# MEMORANDUM

| <b>Service</b>              | WBC Landscape and Trees                                                                                                                                                                                                                                                                                                                                                                                                                                                                                                                                         | <b>App No:</b> | 243190 |
| <b>Address:</b>             | Land south of Bridge Farm, Reading Road, Wokingham, RG2 9HT.                                                                                                                                                                                                                                                                                                                                                                                                                                                                                                    |

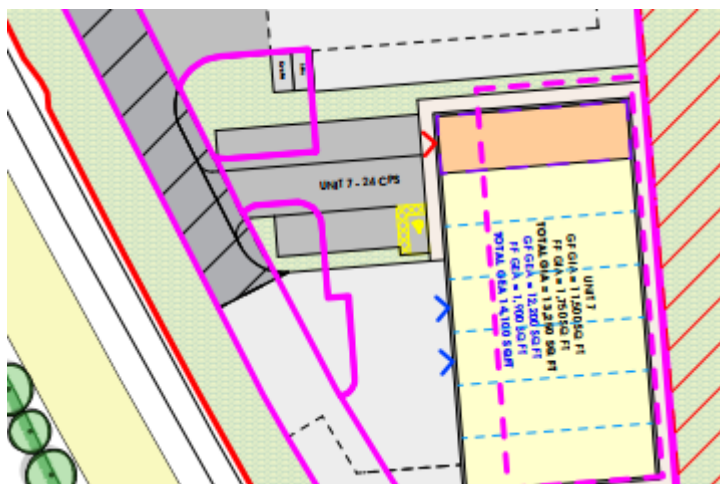
- Unit 7 (previously J & K) are shown to be increased in width by approximately 5.5m although slightly reduced in length.
- The increased area of hardstanding has decreased areas of tree planting between the areas of the parking.

- Some of the disabled bays are now shown to extend into the landscaped areas including abutting the 15m buffer zone to the ancient woodland.
- Bin and cycle stores are also now located in the landscaped spaces reducing areas for strategic landscaping. Some of the bin and cycle stores are not conveniently located, either for bin collection or for cycle parking.

- A substantial area of landscape planting (outlined in pink) to the front of unit 7 as now been considerably reduced and replaced by parking or hardstanding (see extract below).
